Plan Commission

[2019-0756](#) LaGrange Square - Development Petition for a Special Use Permit Amendment with Modifications, Site Plan, Elevations, Landscape Plan, and Subdivision

File Number: **2019-0756**
Orig. Department: **Development Services Department**
File Name: **LaGrange Square - Development Petition for a Special Use Permit Amendment with Modifications, Site Plan, Elevations, Landscape Plan, and Subdivision**

**FINAL PLAT OF
 KDP ORLAND PARK RESUBDIVISION**
 A PART OF THE SOUTHWEST 1/4 OF SECTION 10, TOWNSHIP 36 NORTH,
 RANGE 12 EAST OF THE 3RD PRINCIPAL MERIDIAN, COOK COUNTY, ILLINOIS

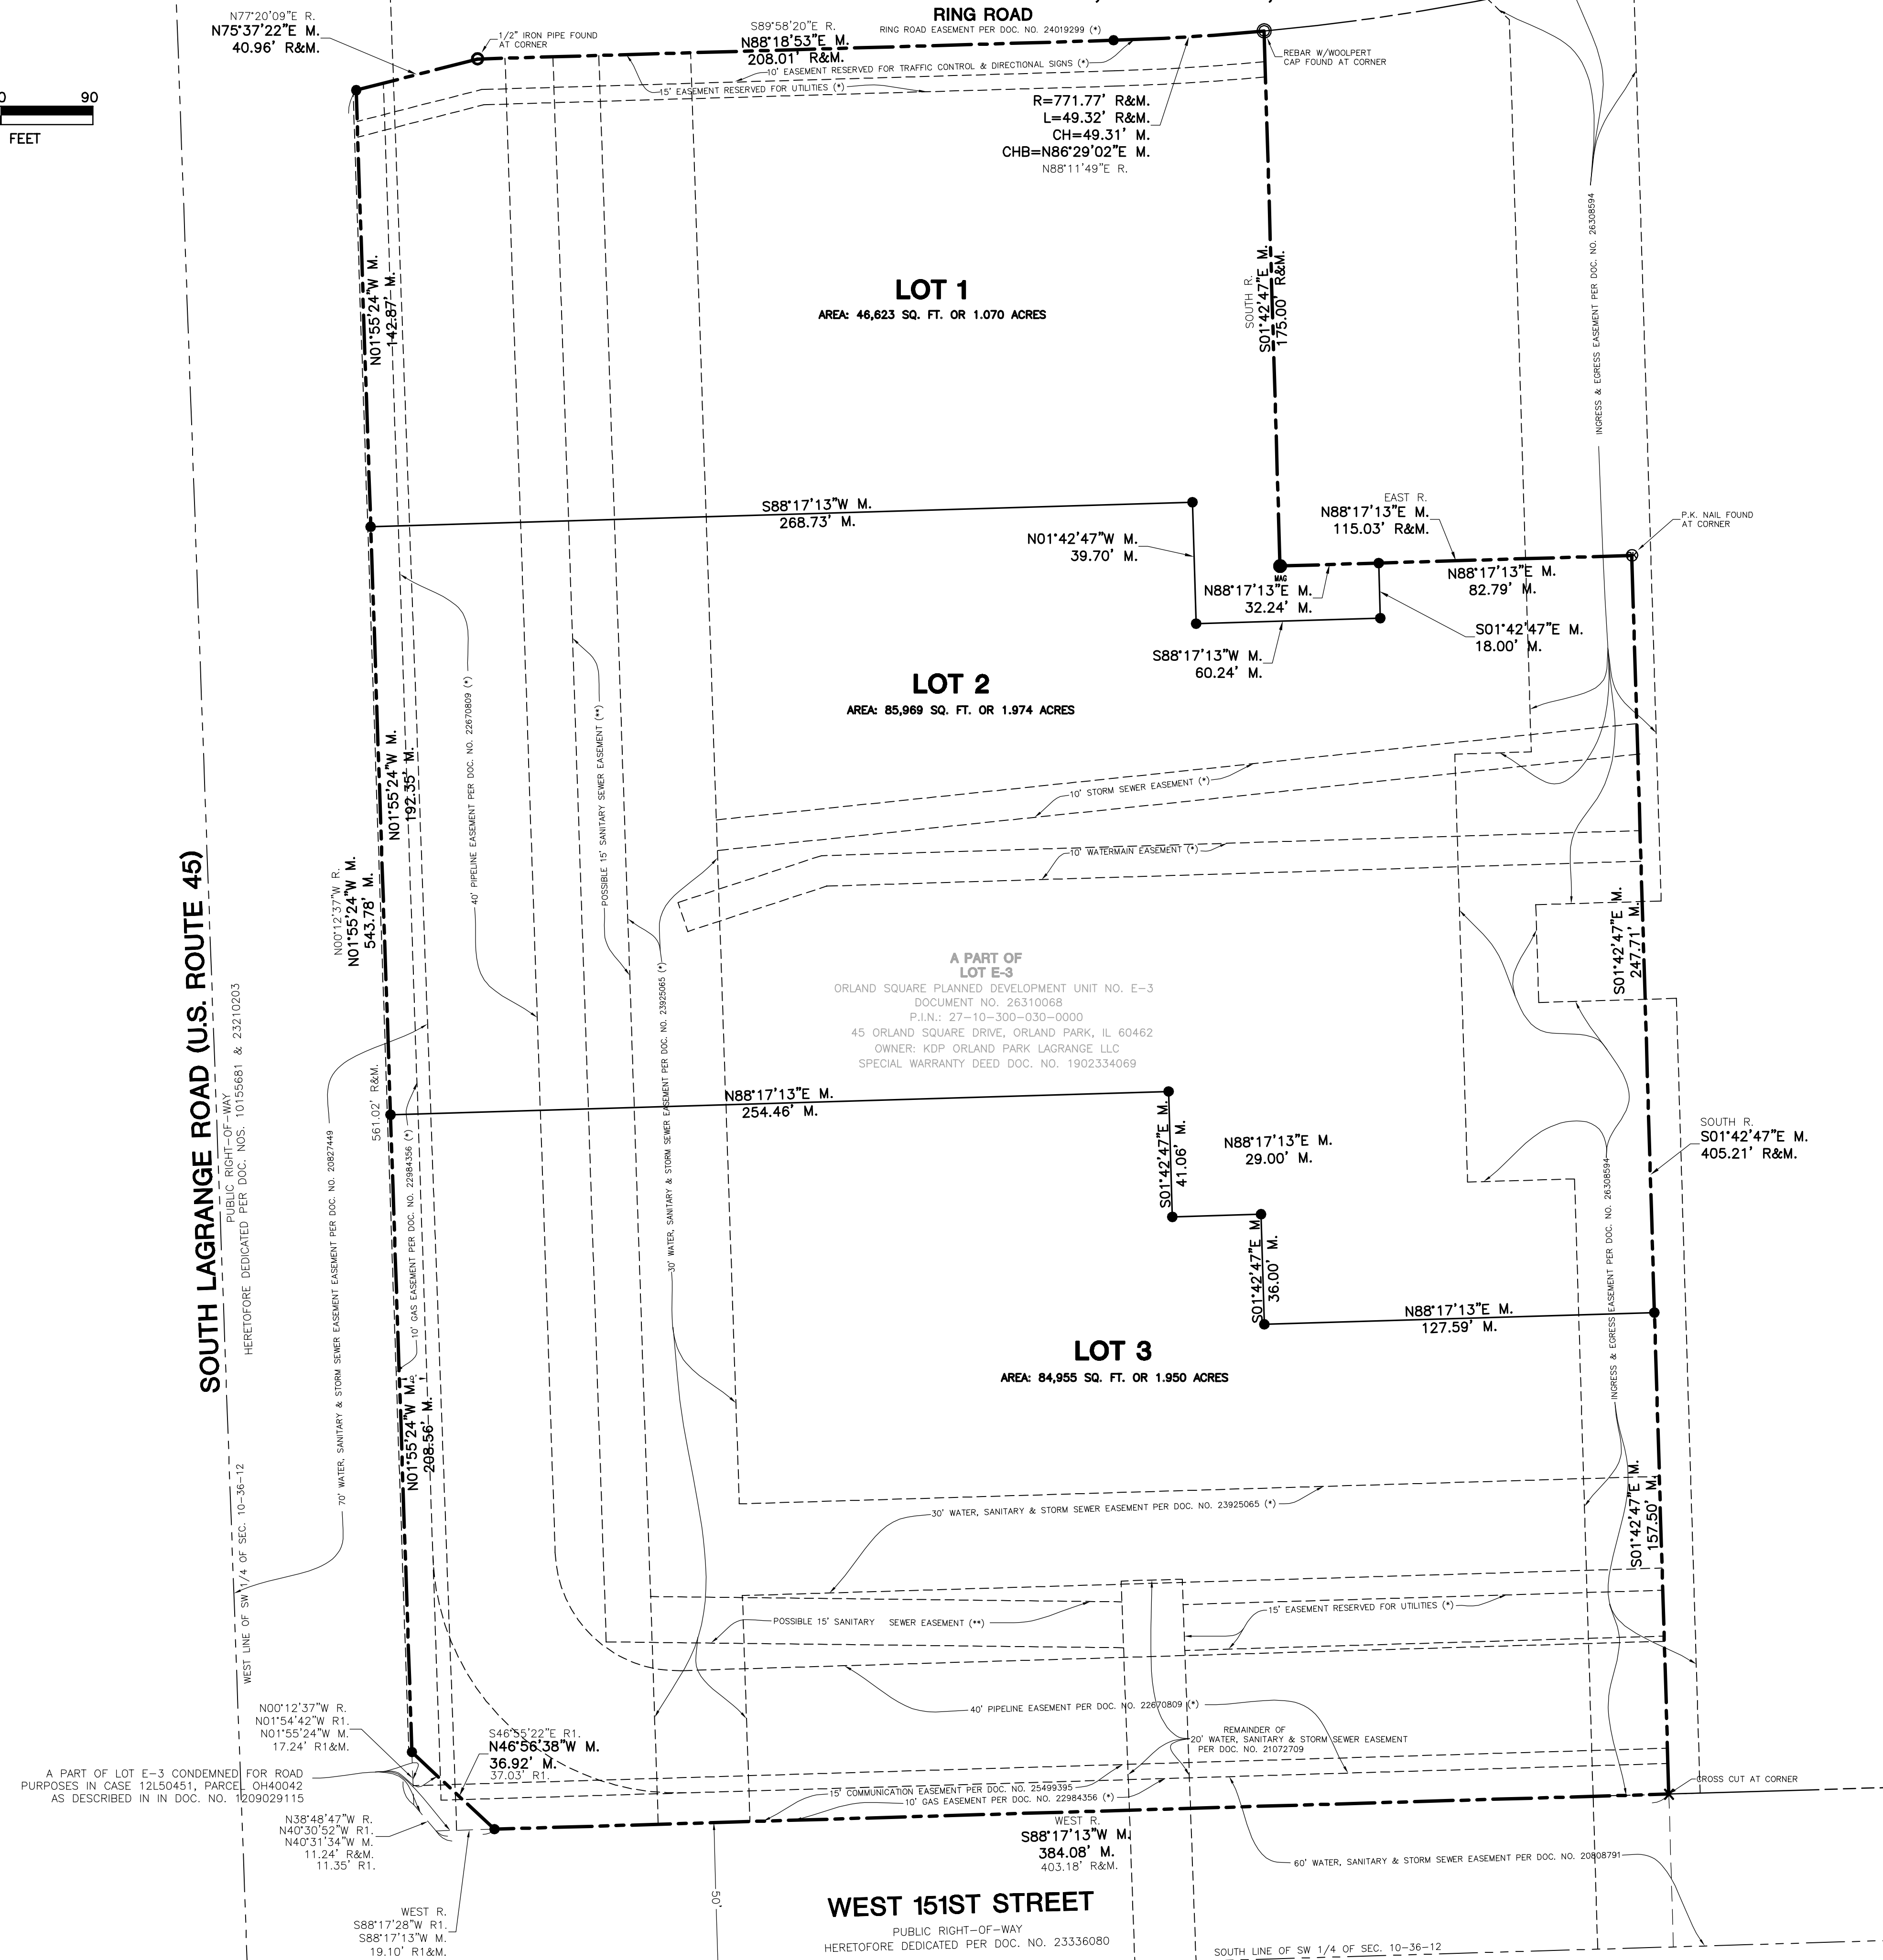
I move to recommend to the Village Board of Trustees to approve the **Plat of Subdivision**, titled "Final Plat of KDP Orland Park Resubdivision", prepared by Woolpert, Inc., dated May 31, 2019, and last revised February 11, 2020, subject to the following condition:

1. Change the title of the plat to "Plat of Subdivision - LaGrange Square."
2. Include the granting of any new easements or the vacation of existing easements on the Plat of Subdivision to reflect any changes to the utilities on site.
3. Provide a cross-access easement and shared parking agreement between all properties on site and to ensure that all lots will maintain proper ingress and egress.
4. Submit a Record Plat of Subdivision to the Village for approval, execution and recording.

SHEET NO.	C200
-----------	-------------

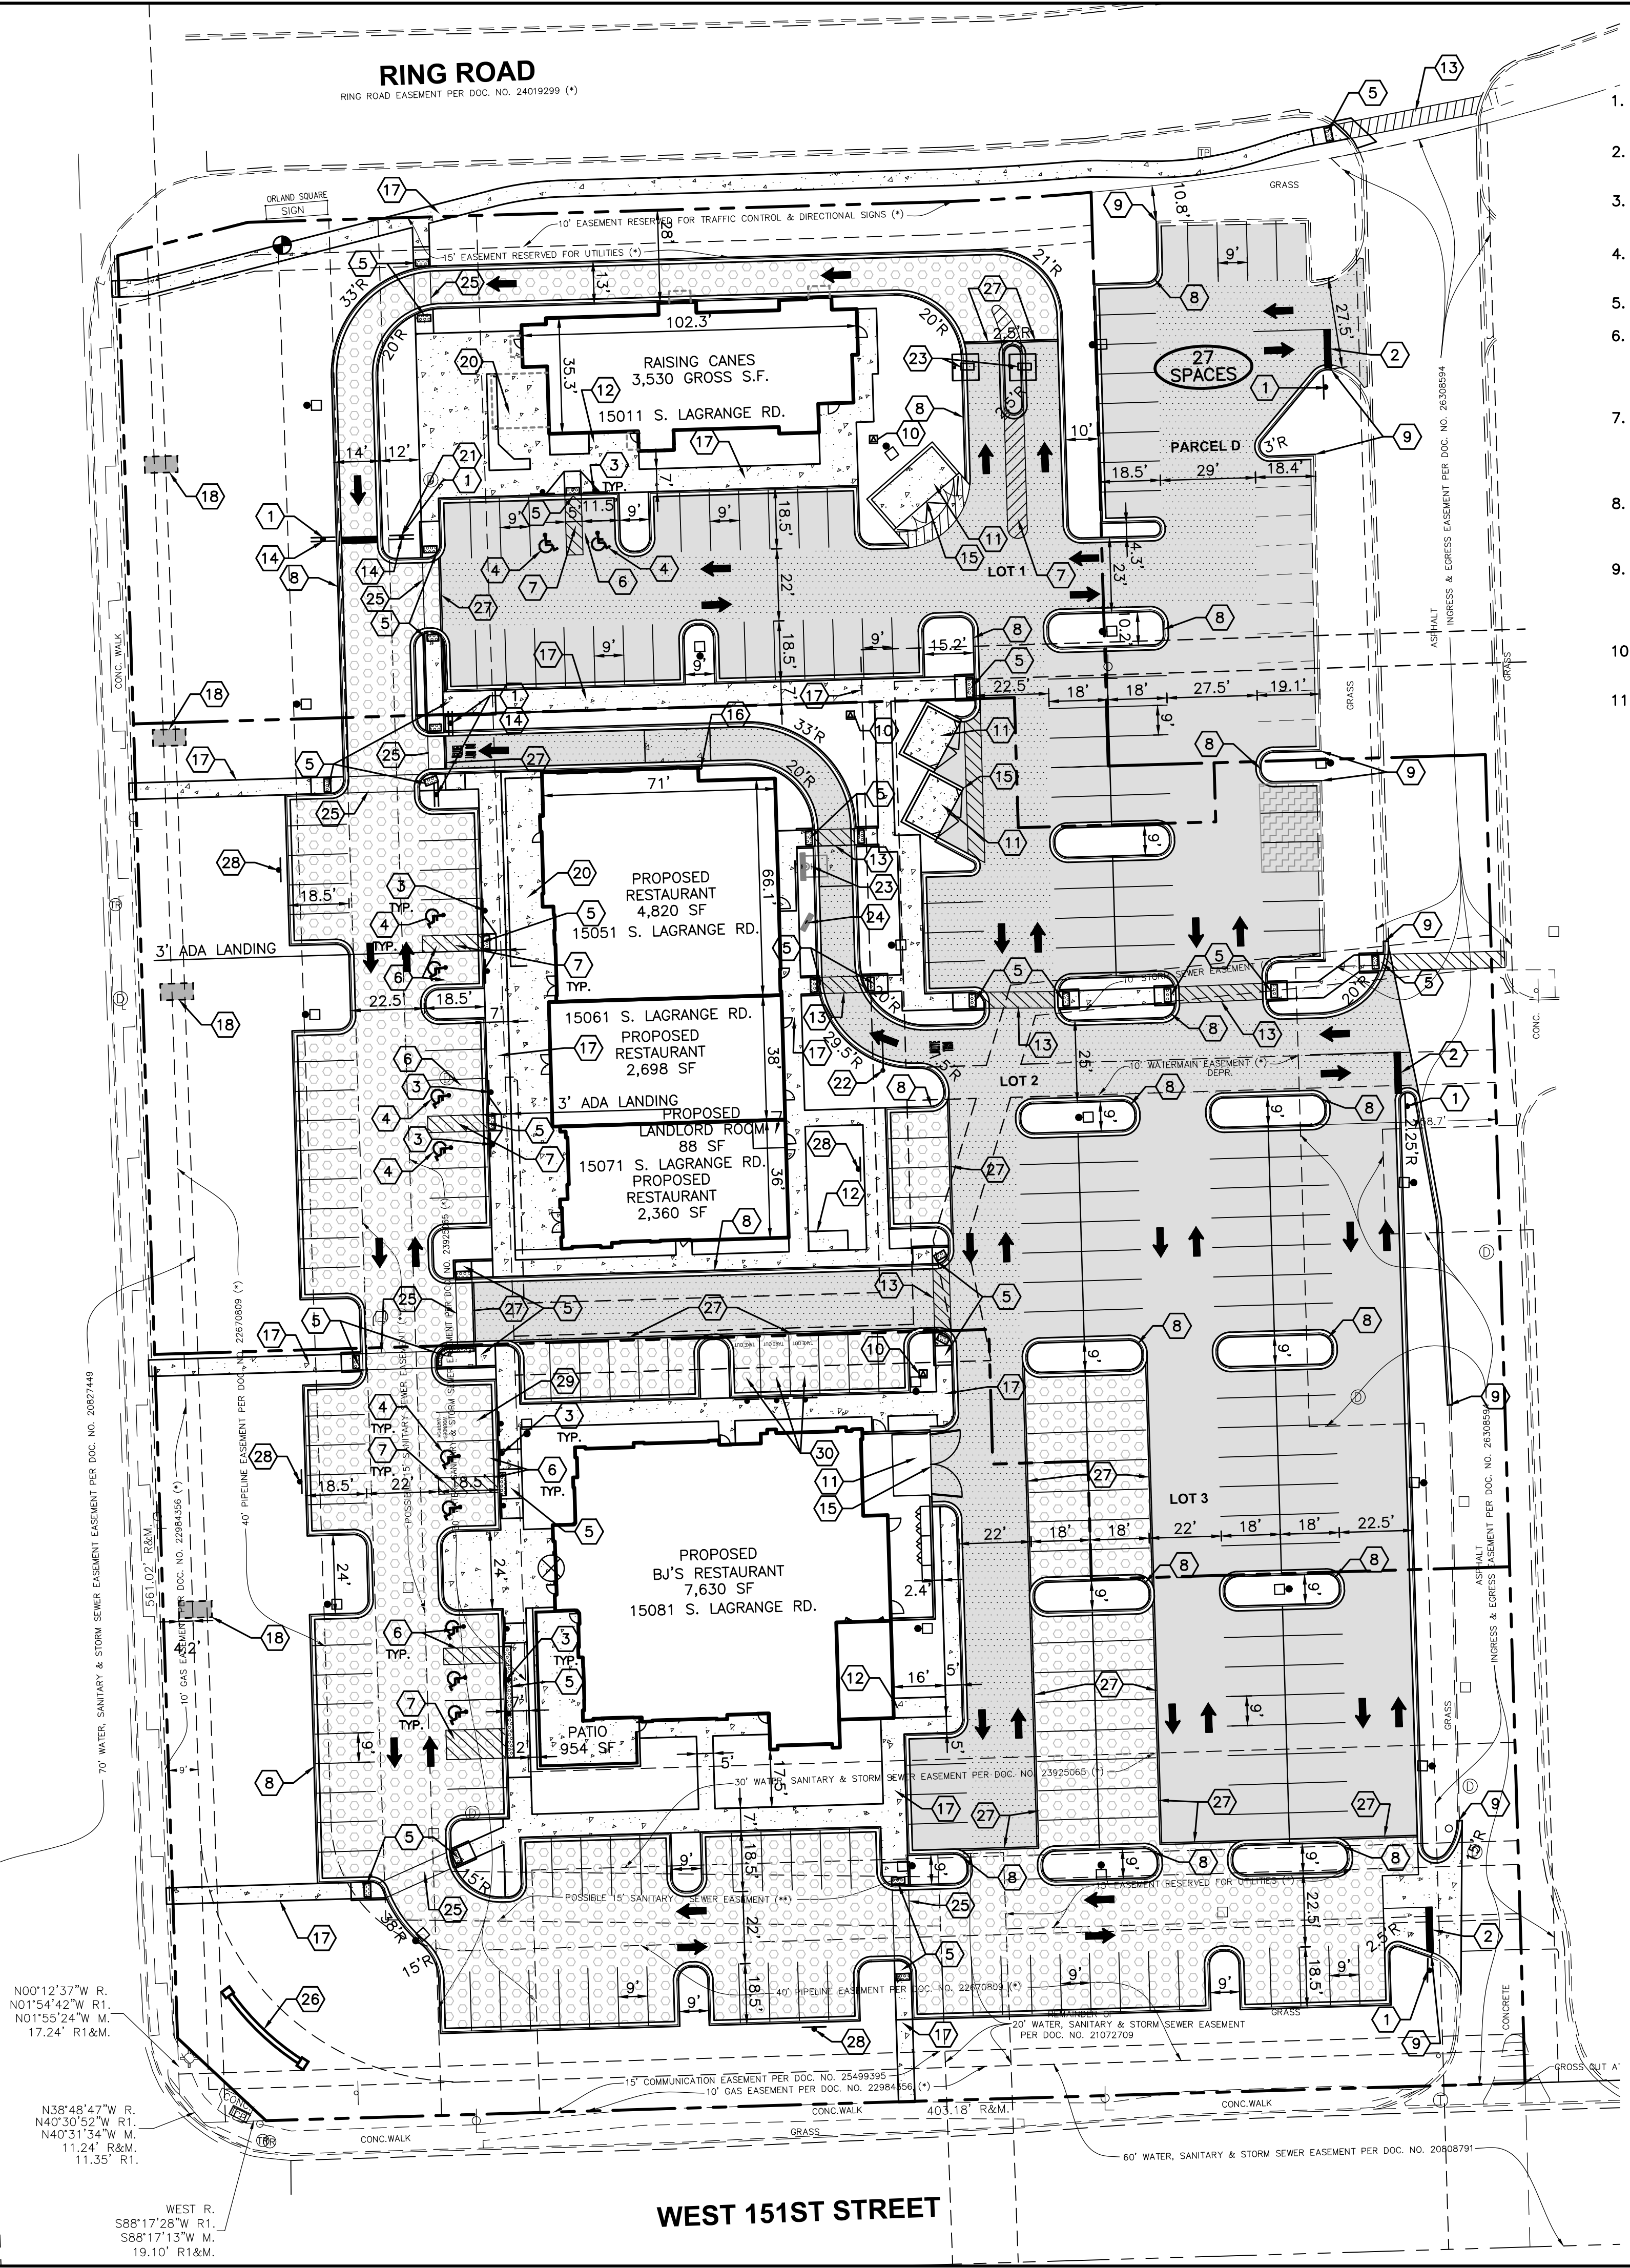
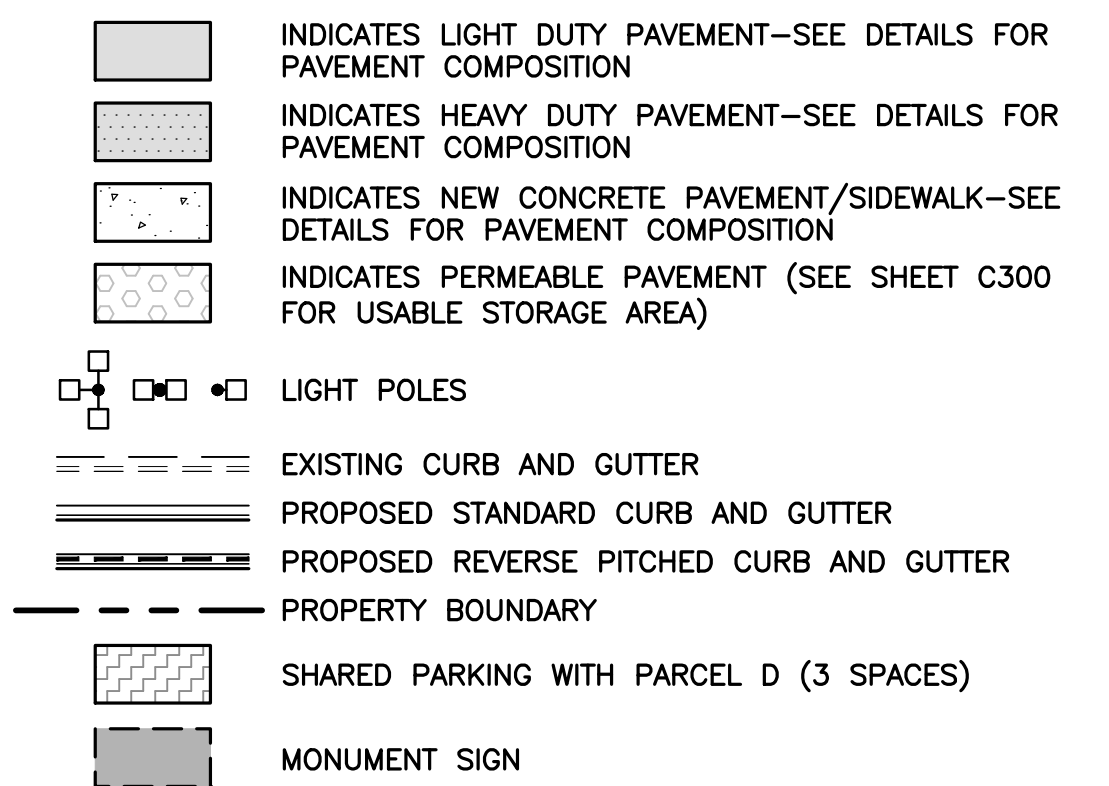
I move to recommend to the Village Board of Trustees approval of the **Preliminary Site Plan** titled "Site Plan" (Sheet C200) and "Site Data Plan" (Sheet C201), prepared by Woolpert, Inc., dated October 10, 2019, and last revised February 25, 2020, subject to the following conditions:

1. Meet all building code requirements and final engineering requirements, including required permits from outside agencies.
 2. Screen all mechanical equipment either at grade or at rooftop with landscaping or parapets respectively.
 3. Submit a sign permit application to the Development Services Department for separate review. Signs are subject to additional review and approval via the sign permitting process and additional restrictions may apply.
 4. The photometric plan shall comply with all lighting requirements per Section 6-315.
 5. Provide additional plant material between the proposed drive-through lane on Lot 1 and the adjacent streets (LaGrange Road and the Ring Road) to screen the drive-through lane from the
-

7. Provide a cross-access easement and shared parking agreement between all properties on site and to ensure that all lots will maintain proper ingress and egress.
